TOLERANCES UNLESS OTHERWISE SPECIFIED		SLR-45	
FRACTIONS	DEC	ANGLES	
* * *	* * *	* * *	
APPROVALS	DATE		
DRAWN	LSL 10/79		
CHECKED		SCALE	SIZE
			C
		DRAWING NO.	
		DO NOT SCALE DRAWING	
		SHEET

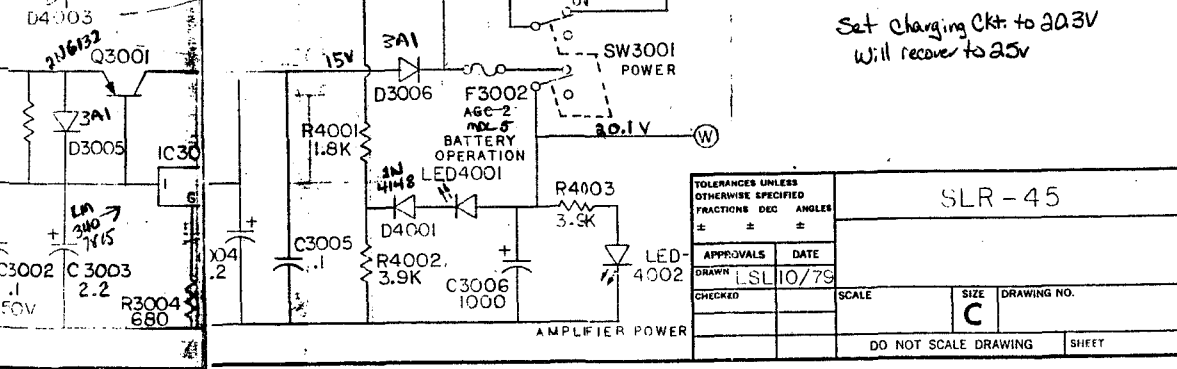
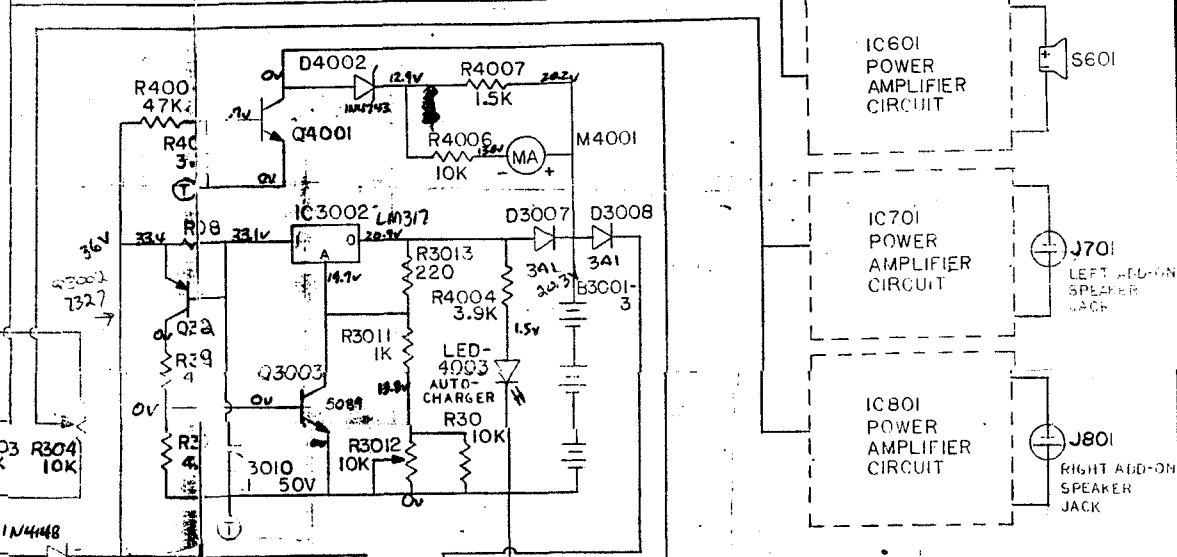
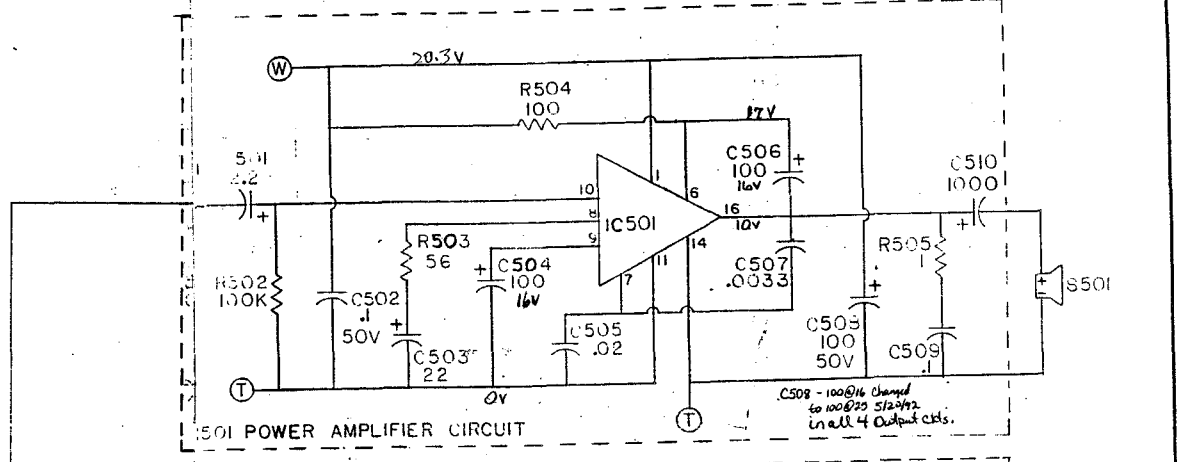
C502 - 100/16 changed to 100/25 512442 in all 4 output ckt's.

Set charging Ckt. to 20.3V will recover to 25V
